Life Textile (Pvt) Ltd. (10140)

ACCORD
on Fire and Building Safety in Bangladesh

Identified Priority 1 Concerns

Priority 1 Concern

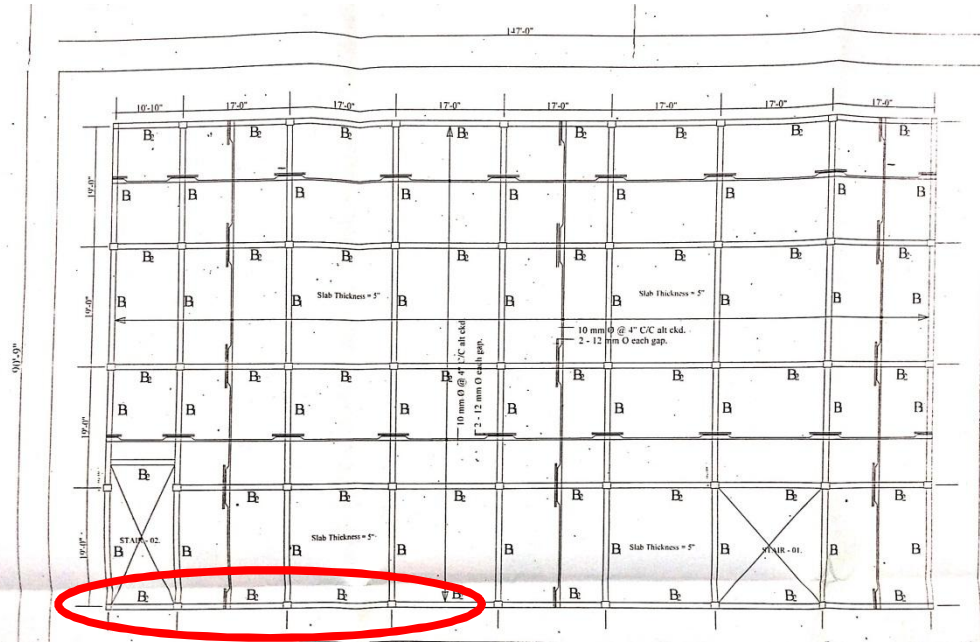
The central columns are significantly overloaded and have a factor of safety less than 1.25.

- The interior columns are overloaded and therefore we recommend the 4th, 5th, 6th, and roof slabs be evacuated and all imposed loading is removed down to 0 kPa.

- A detailed engineering assessment be carried out to more accurately determine the load carrying capacity of the columns.
- Load plan diagrams are prepared and posted.

3rd Priority 1 Concern

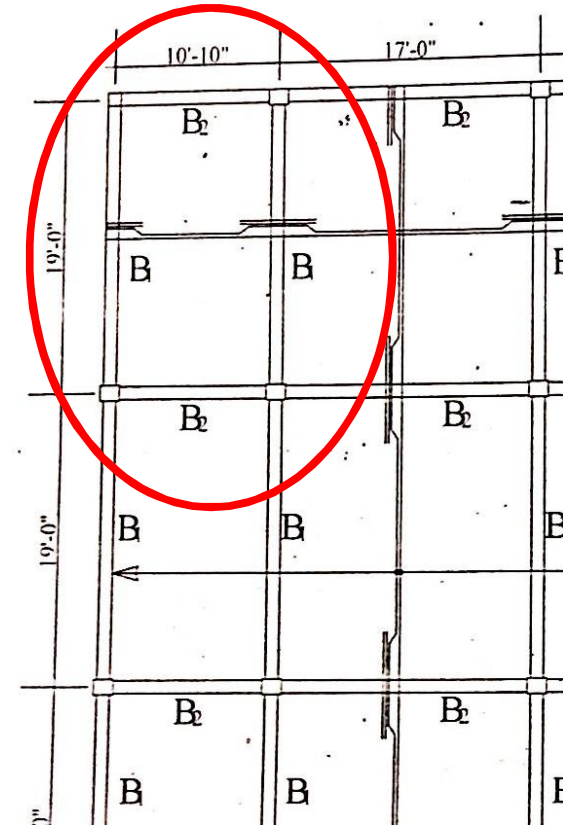
The toilet block to East side of building is not built in accordance with the structural drawings. This cantilevers out by 3m with gallow brackets. There is visible significant deflection in the slab between supports.

- Due to the excessive slab deflection and the lack of information shown on the structural drawings we recommend the toilet block be evacuated and kept unoccupied.

- An engineering assessment be carried out to determine the structural integrity of the SE corner toilet block.

Priority 2 Concern

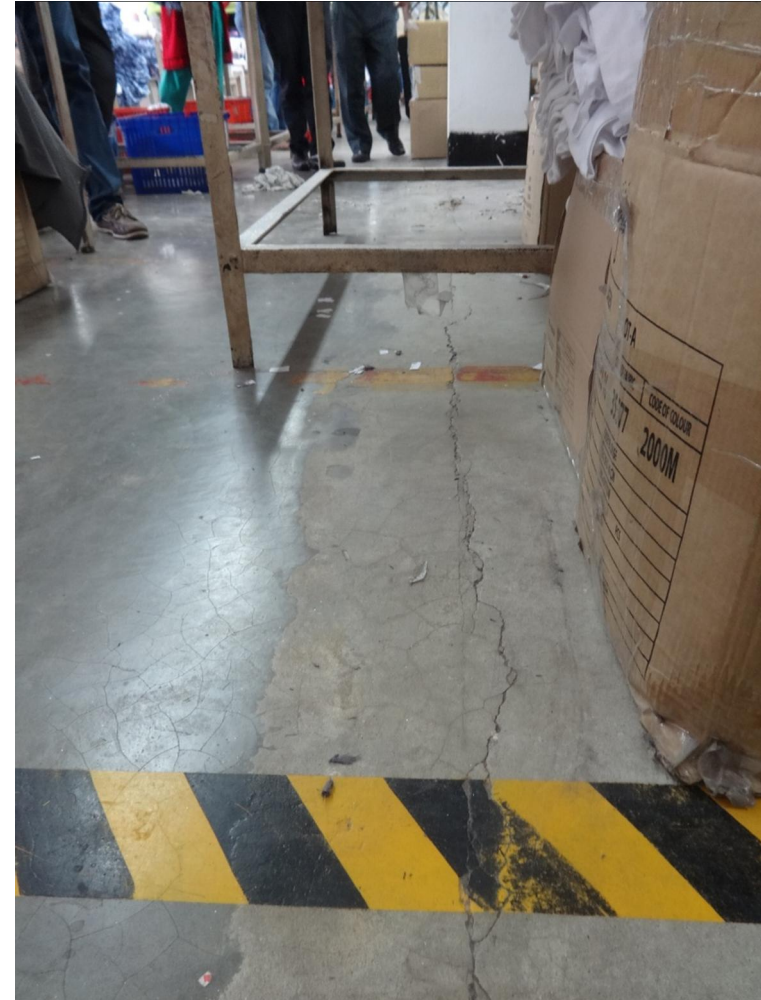
Multiple cracks to beam and slab were observed at all floors. The beams had shear and flexural cracks, suggesting overloading. The slabs were cracking over the beams, suggesting inadequate tensile reinforcement. Much of the factory had been recently decorated making it difficult to observe all of the cracking. The crack to the beam shown in red for clarity.

- An engineering assessment be carried out to determine the cause of cracking and to ensure structural integrity.

Priority 2 Concern

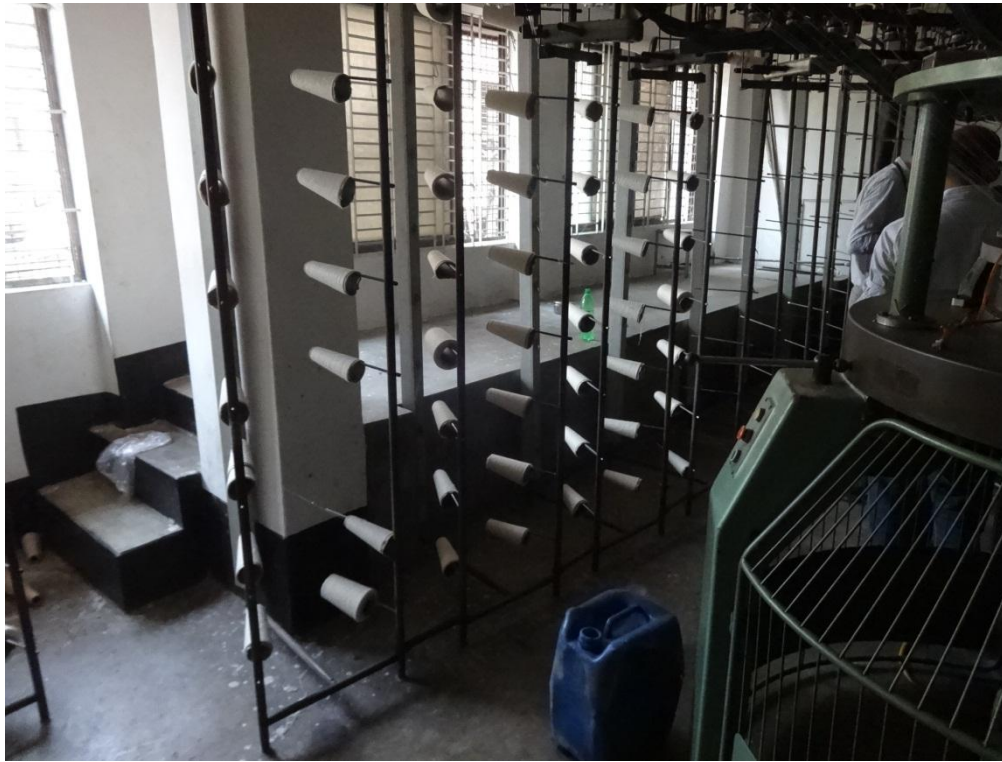
Materials lift did not appear to be adequately detailed or connected to primary structure. There was extensive damage and corrosion to the steelwork.

- An engineering assessment be carried out to determine the structural integrity of the materials lift.

Priority 3 Concern

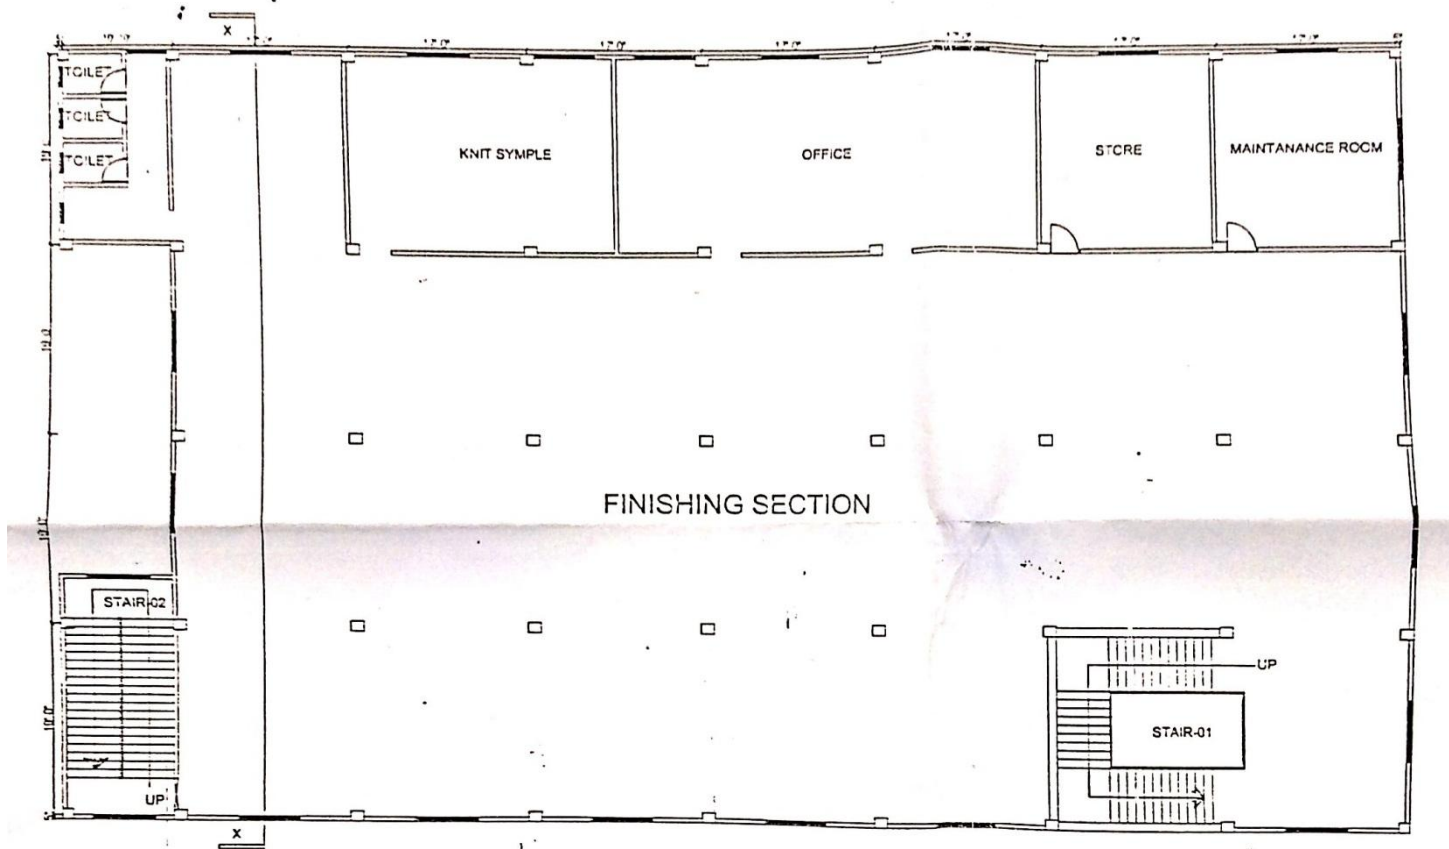
At first floor level a masonry up-stand has been constructed on top of the cantilever. This adds approximately 15kN/m^2 of dead load to the tip of the cantilever, and neither the up-stand or the cantilever is shown on the structural drawings.

- An engineering assessment be carried out to determine the structural integrity of the elements supporting the concrete up-stand.
